# Kinetis 100 MHz Rev 1.x to Rev 2.x Migration Guide

This document shows differences and describes the details of migrating from Kinetis 100 MHz Rev. 1.x to Rev. 2.x.

Figure 1. PMC\_REGSC

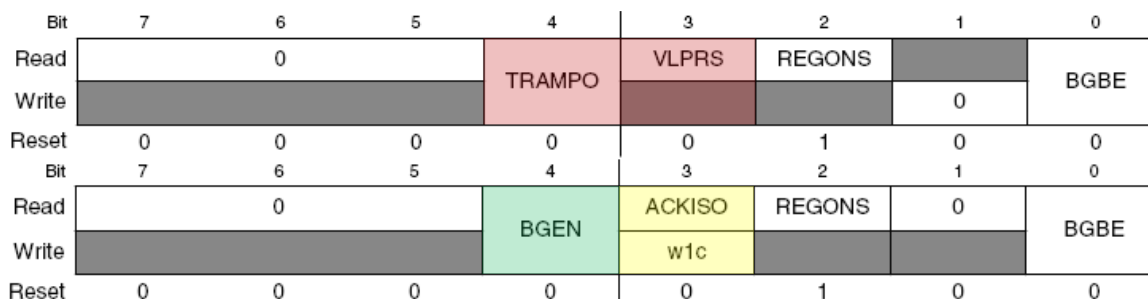
- TRAMPO—Removed in Kinetis 100 MHz Rev. 2.x/120 MHz
- VLPRS—Removed in Kinetis 100 MHz Rev. 2.x/120 MHz
- BGBE—Bandgap Buffer Enable

**TRAMPO:** The TRAMPO bit has been removed. There is a new bit in the SMC—RAM2PO—that controls the RAM power in VLLS2. The new RAM2PO bit has different functionality, however.

**VLPRS:** The VLPRS bit has been removed. Software only needs to check the Run Regulator Status and the SMC\_PMSTAT register when entering VLPR mode. The REGONS bit will clear when the regulator is in stop regulation or transition to/from it and the SMC\_PMSTAT will read 04 when the MCU power mode is in VLPR.

**Bandgap Enable:** This new bit controls the enable of the bandgap circuit. If the VREF module is operational, the BGPE bit should be set. Note that if the BGBE is set, the bandgap circuit will remain enabled and will consume current in all of the power modes. To keep the current to a minimum in the lowest power modes, this bit should be cleared prior to mode entry.

**Figure 20. RNG-A block diagram**

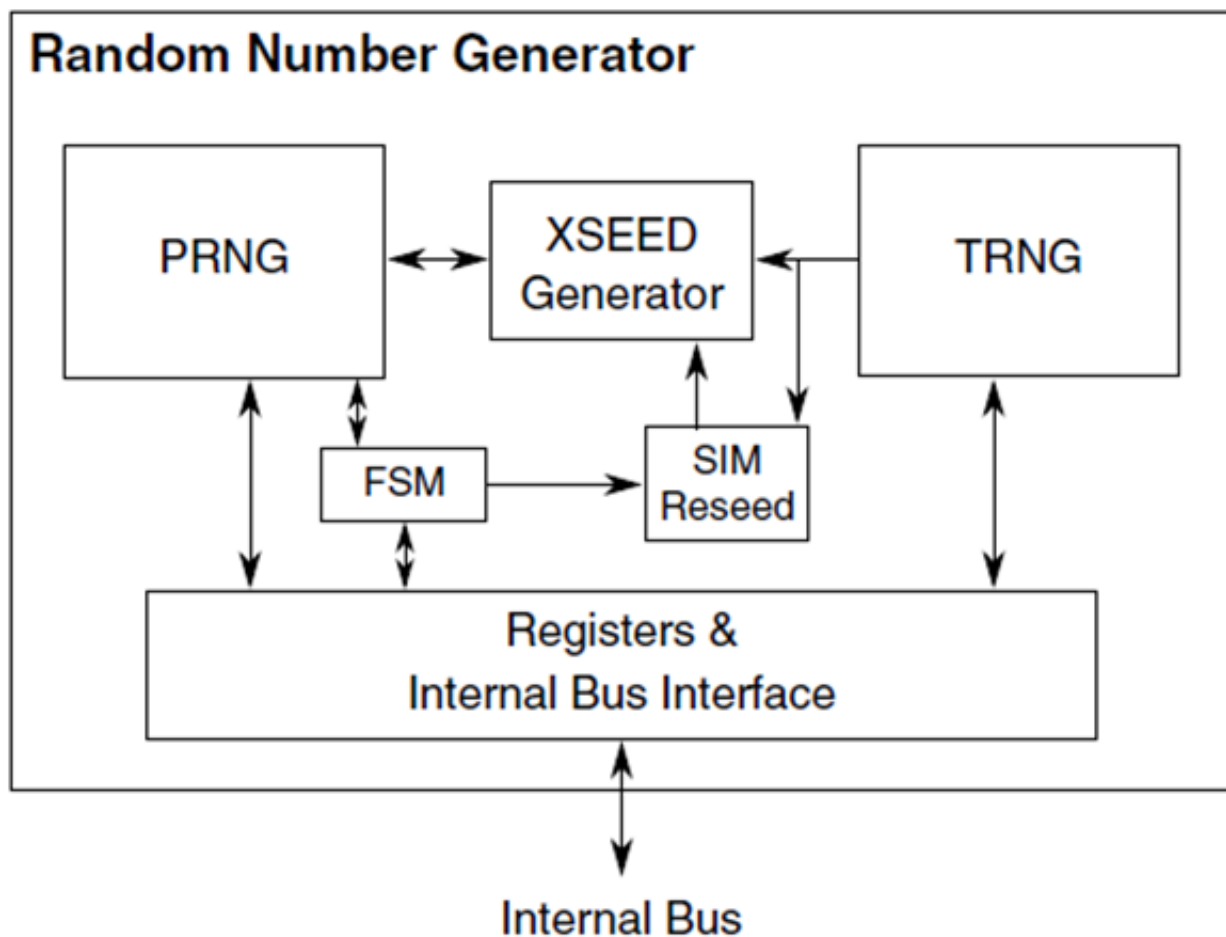
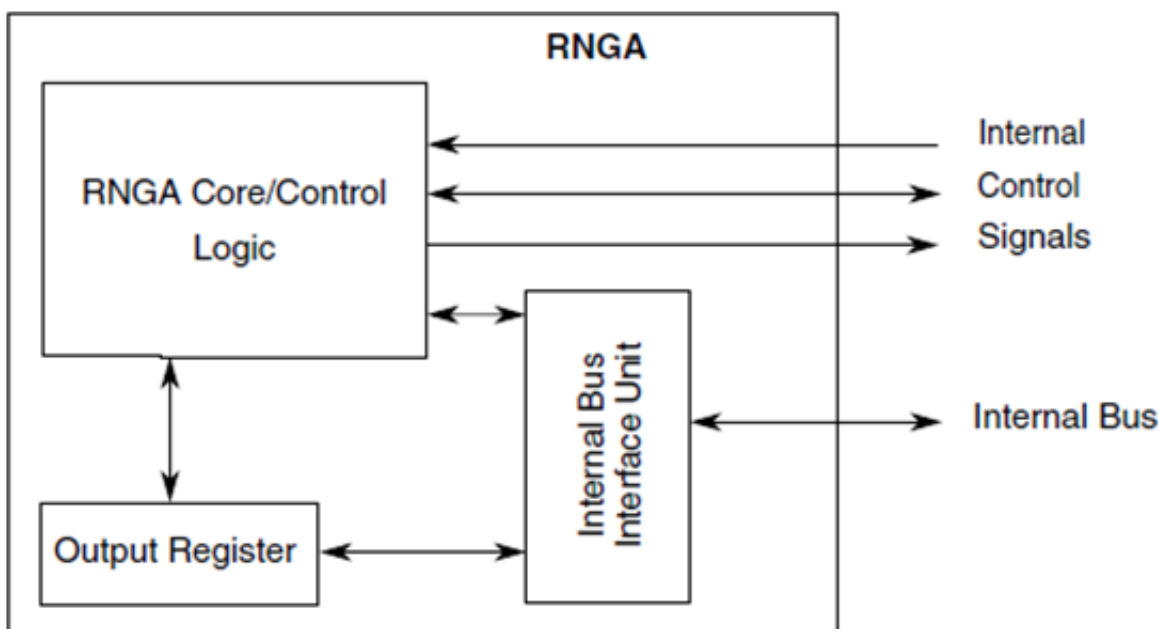
The RNG-A variant is simply a pseudo-random number generator. This module is less bulky and less complex than the RNG-B variant. The RNG-A block diagram is shown in the block diagram below.

There is no known cryptographic proof showing that this is a secure method of generating random data. Therefore, it is highly recommended that the random data produced by this module be used as an input seed to a NIST-approved (based on DES or SHA-1) pseudo-random number generator as defined in NIST Fips Pub 186-2 Appendix 3 and NIST Fips Pub SP 800-90.

Though these modules are very different internally, operationally they are very similar. The RNG-A module does not allow for manual seeding. Thus, only the automatic operation algorithms will be compared here. The two different initialization and operation modes are displayed below.

**Figure 22. RNG-A module RNG\_CR**

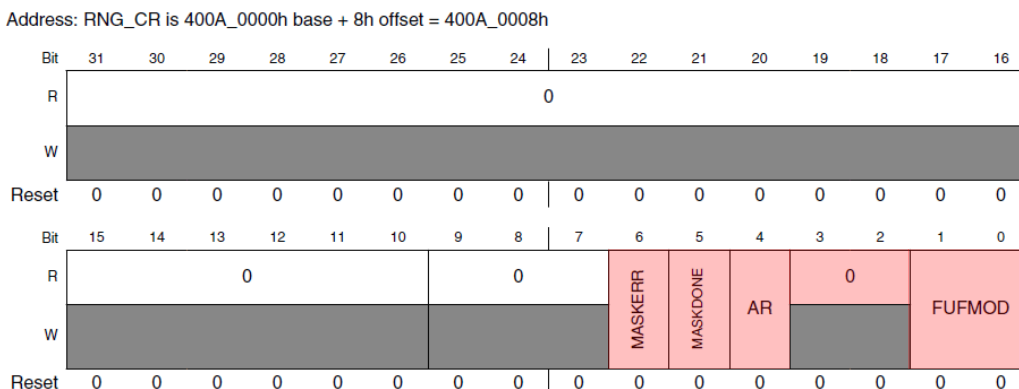
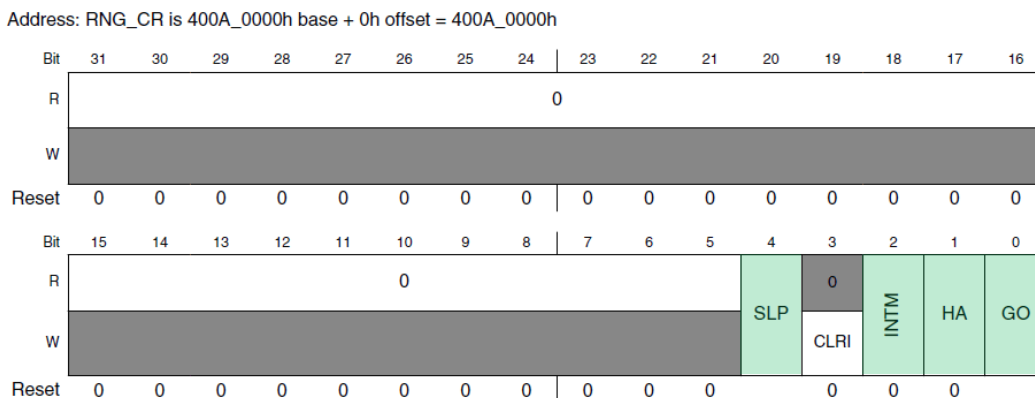
- MASKERR
- MASKDONE
- AR
- FUFMOD

- SLP: Setting this bit puts the RNG module in Sleep mode; clearing this bit awakens it.
- CLRI: Setting this bit clears the error interrupt flag.
- INTM: Setting this bit enables RNG interrupts; clearing it disables them.
- HA: Enables the security violation bit in the RNG register. Reads of the RNG register while this bit is set are not permitted.
- GO: RNG register is loaded with random data.

**Figure 25. RNG-A module RNG\_SR**

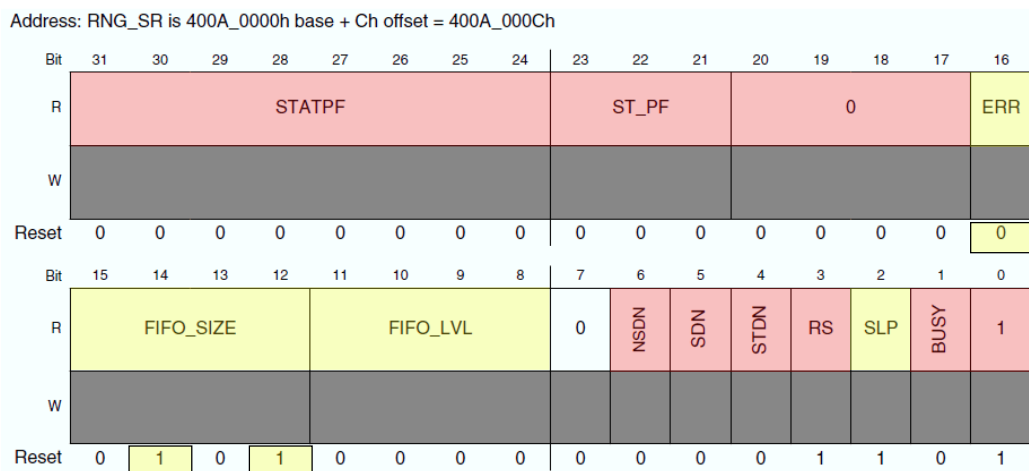
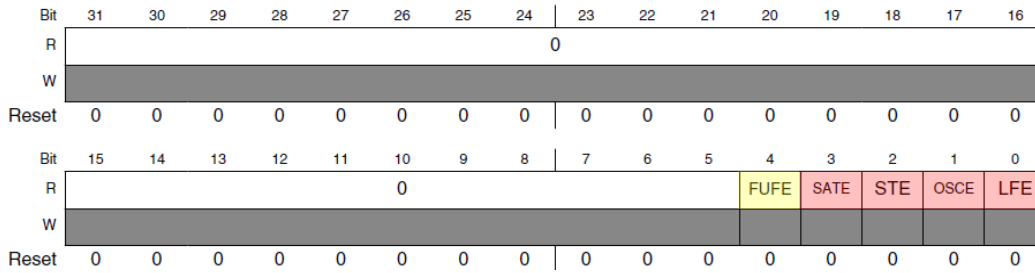
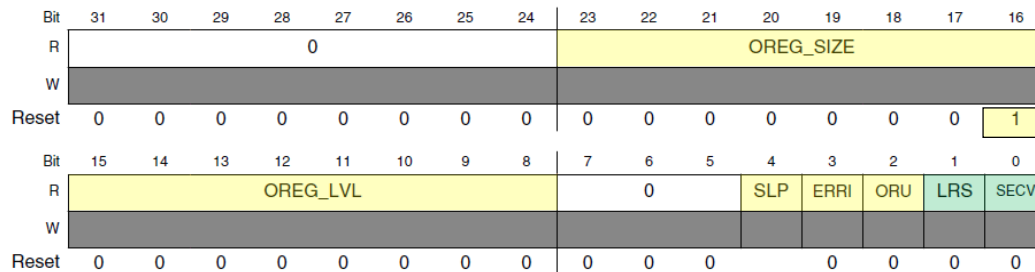
- SECV: Signals that a security violation has occurred if set. No security violation has occurred if cleared.
- LRS: When set, the last read status bit indicates that the last read was performed while the output register was empty (underflow condition).

- OREG\_SIZE: This is an 8-bit integer field that indicates the size of the output register and has been renamed from FIFO\_SIZE in the RNG-B variant.
- OREG\_LVL: This bit indicates that a random word is available in the output register. Only two values are possible (0b00000001 or 0b00000000). This bit was renamed from FIFO\_LVL in the RNG-B variant.
- SLP: Indicates that the RNG module is in Sleep mode when set. This bit was moved from bit 2 (in the RNG-B variant) to bit 4.
- ERRI: When set, this bit indicates that the output register was read while empty. This bit was moved from bit 16 (in the RNG-B variant) to bit 3.
- ORU: When set, this bit indicates that the output register was read while empty since the last read of the status register. This bit was moved from bit 4 of the ESR register (in the RNG-B variant) to bit 2.

Figure 29. I2S0\_CR–Rev. 1.x

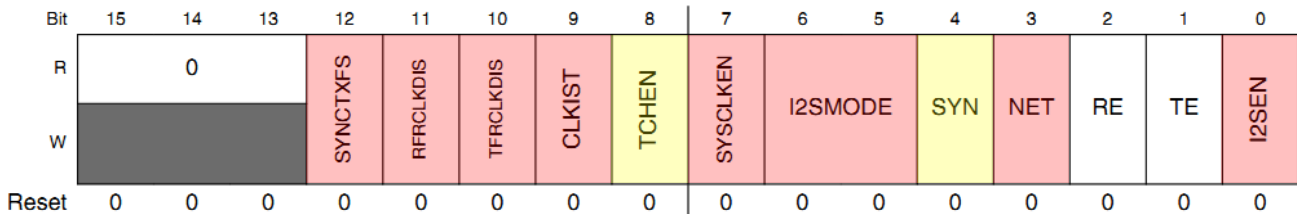
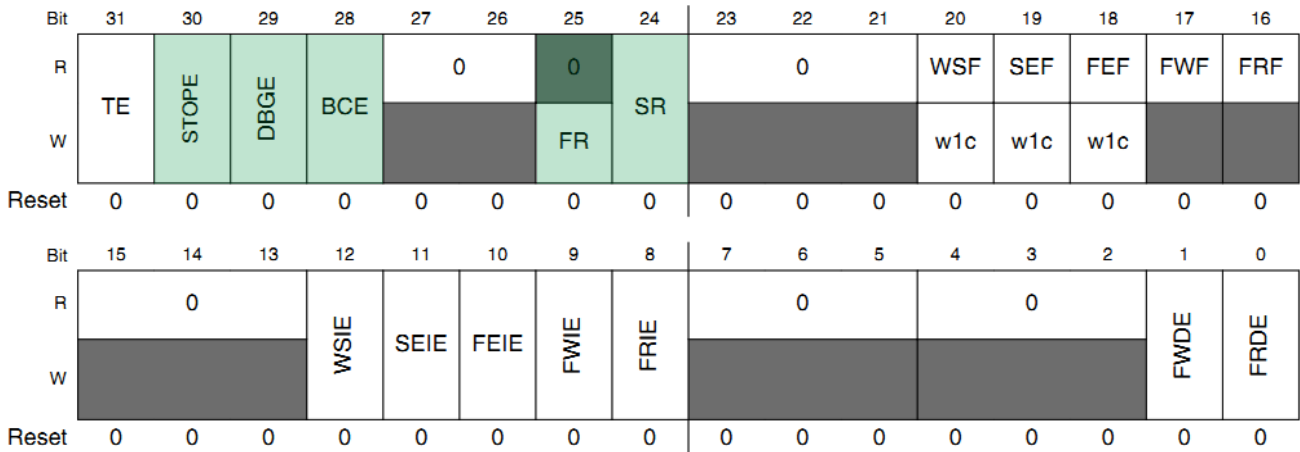
- **SYNCTXFS**: CR[TE] latch with FS occurrence
- **RFRCLKDIS**: Receive Frame Sync Disable
- **TFRCLKDIS**: Transmit Frame Sync Disable
- **CLKIST**: Clock Idle State during I2S Gated Clock Mode
- **SYSCLEN**: Oversampling Clock Enable
- **I2SMODE**: I2S Mode Select
- **NET**: Network Mode I2SEN: I2S enable

Figure 57. SCANC registers (old and new versions)

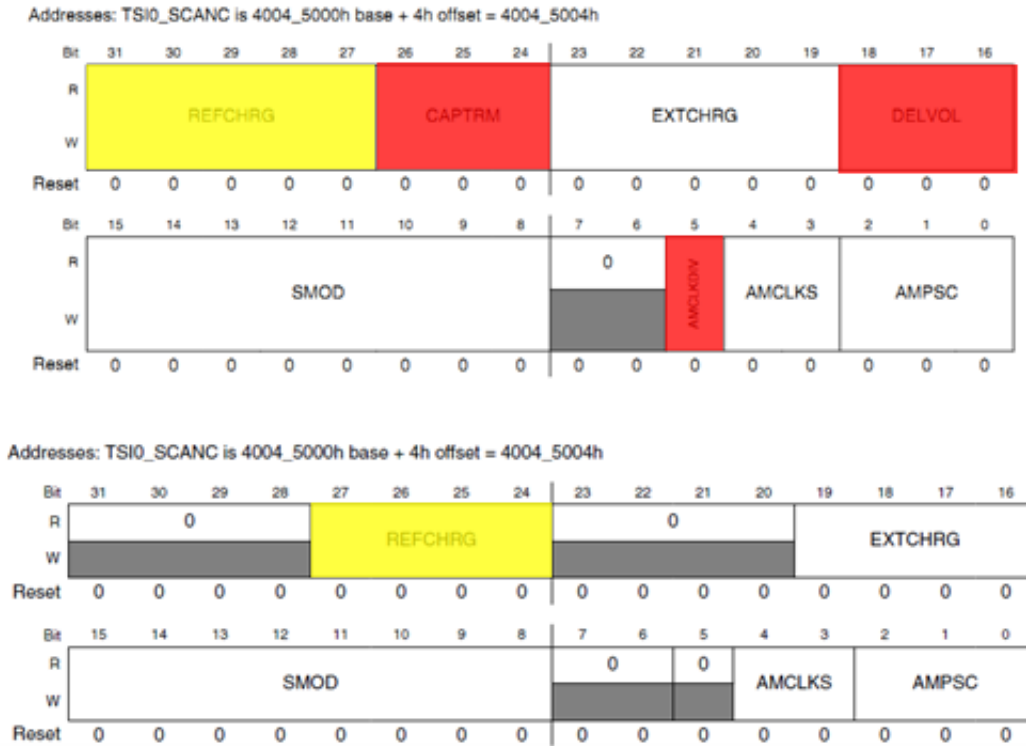
- **GENCS:** No change, but the out-of-range setting is now only operational in low-power modes.
- **SCANC:** **CAPTRM** removed (internal cap is now fixed to 1 pF), **REFCHRG** and **EXTCHRG** have been scaled down from 5 bits to 4 bits. Change involves reducing the amount of possible current values from 32 to 16. Current range is now from 2  $\mu$ A to 32  $\mu$ A in increments of 2. **DELVOL** eliminated, delta voltage value is now fixed. **AMCLKS** clock sources changed: bus clock reference was changed for **LPOCLK**. **AMCLKSDIV** was also removed because it was only practical with bus clock as reference. Instead of dividing down the clock source, now a slower, lower power source can be used. This reduces overall power consumption of the module. If a slow source is needed, use **LPOCLOCK** and adjust with **AMPSC**. If a faster source is needed, use **MCGLRCLK** or **OSCERCLK**.

Figure 58. TSI\_STATUS (completely removed)

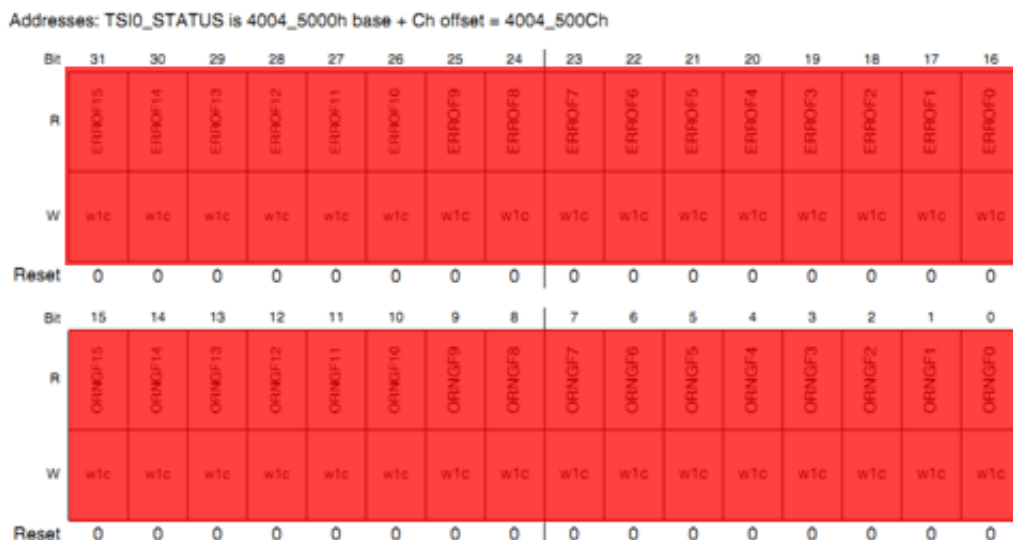
- **TSI\_STATUS:** Removed

- Remove references to TSI\_STATUS, as it is no longer available.
- Remove references to the numbered TSI\_THRESHLDn registers; remember now only one TSI\_THRESHOLD register, with the OURGF flag and interrupt, is used for wakeup.

Figure 59. Single TSI\_THRESHOLD for wakeup instead of separate registers for each channel

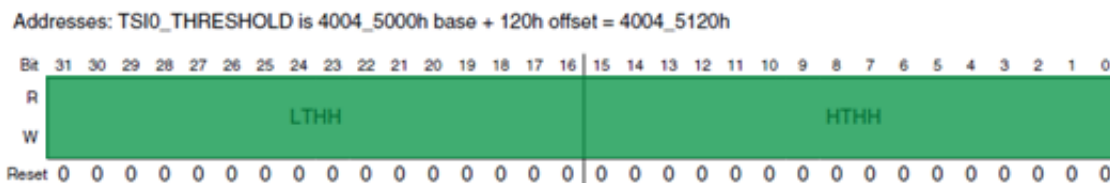
- **TSI\_CNTR:** No change
- **TSI\_THRESHLDn:** Used to be one threshold register for each electrode; now there is a single threshold register for the selected wakeup electrode because the out-of-range function now only operates in low-power modes.

Figure 66. SIM\_SOPT2—Rev. 2.x

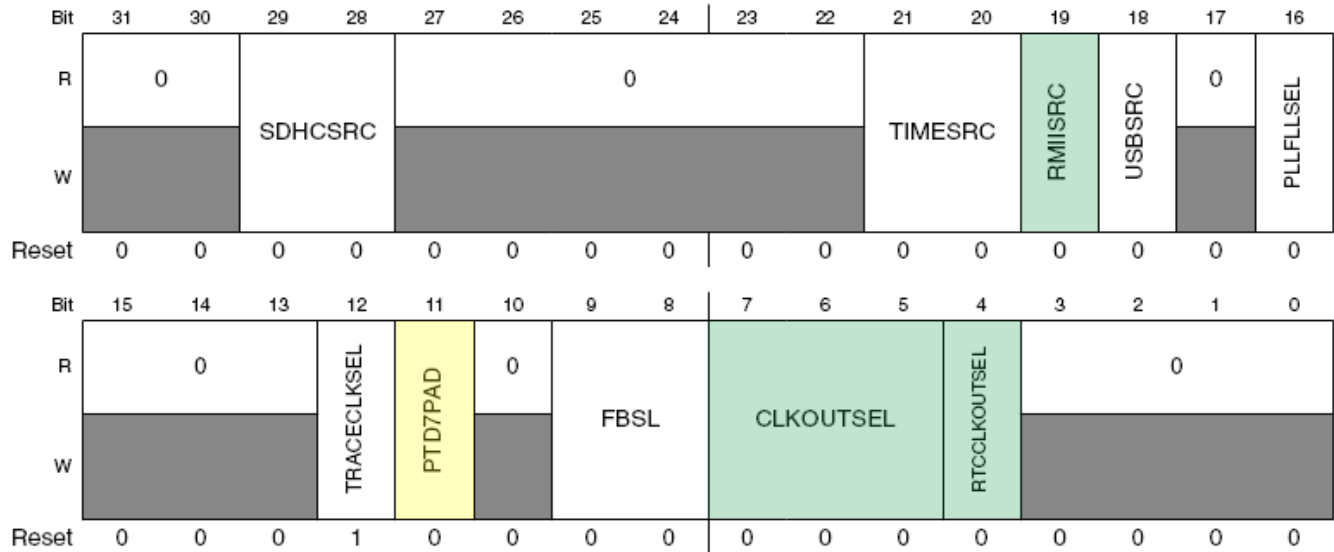
- CMTUARTPAD → PTD7PAD bit field renaming with no functional change

Figure 68. SIM\_SOPT4—Rev. 2.x

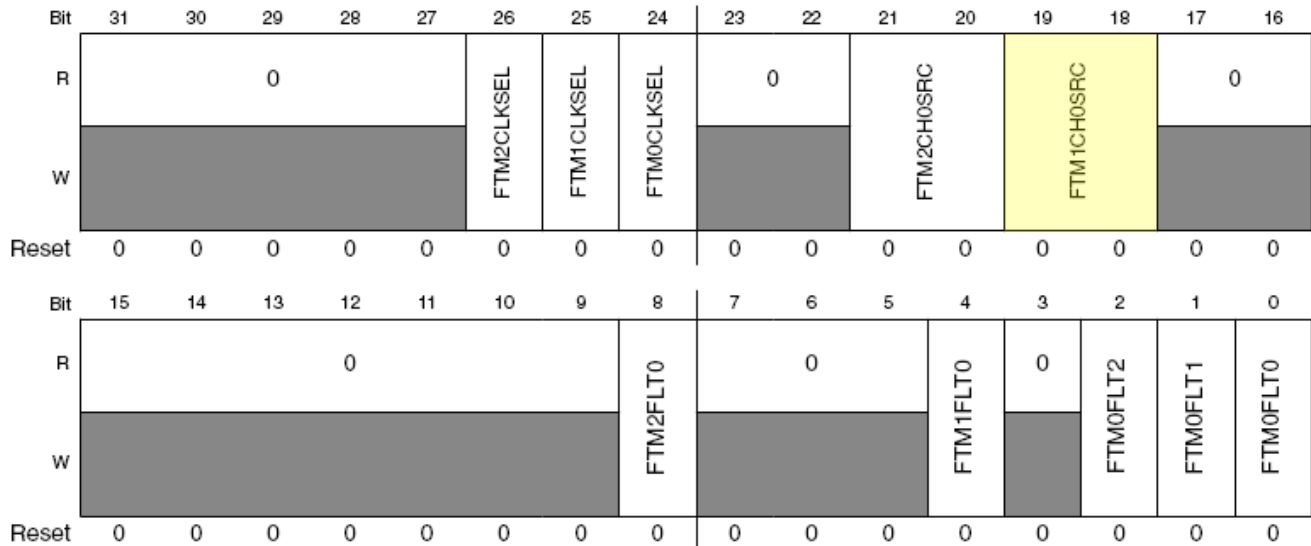
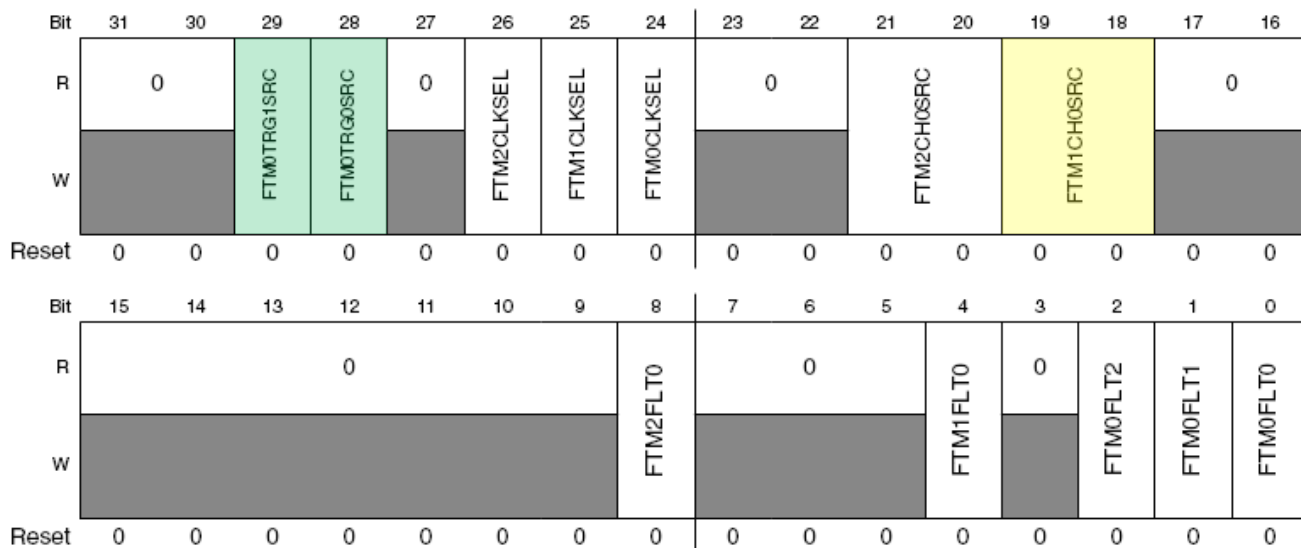
- FTM1CH0SRC → Added option for the USB Start-of-Frame Pulse

Figure 69. SIM\_SOPT6—Rev. 1.x

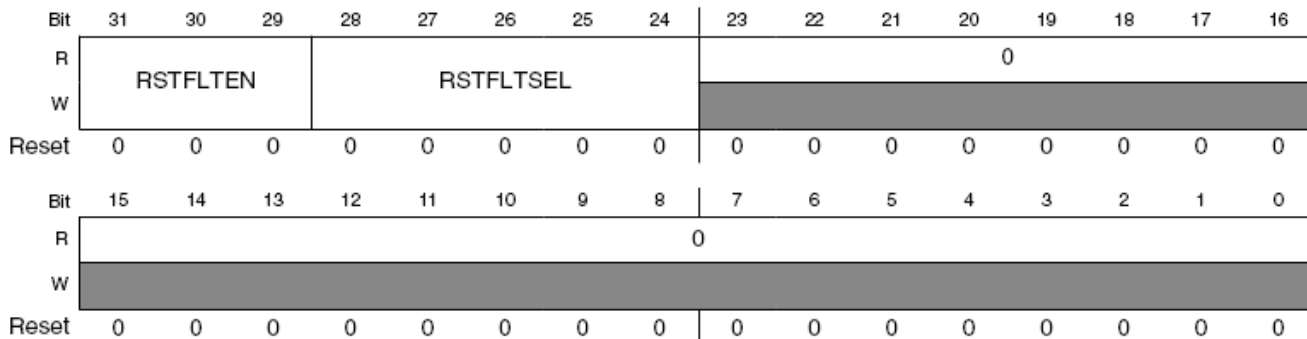
Register removed and bit fields moved to RCM.
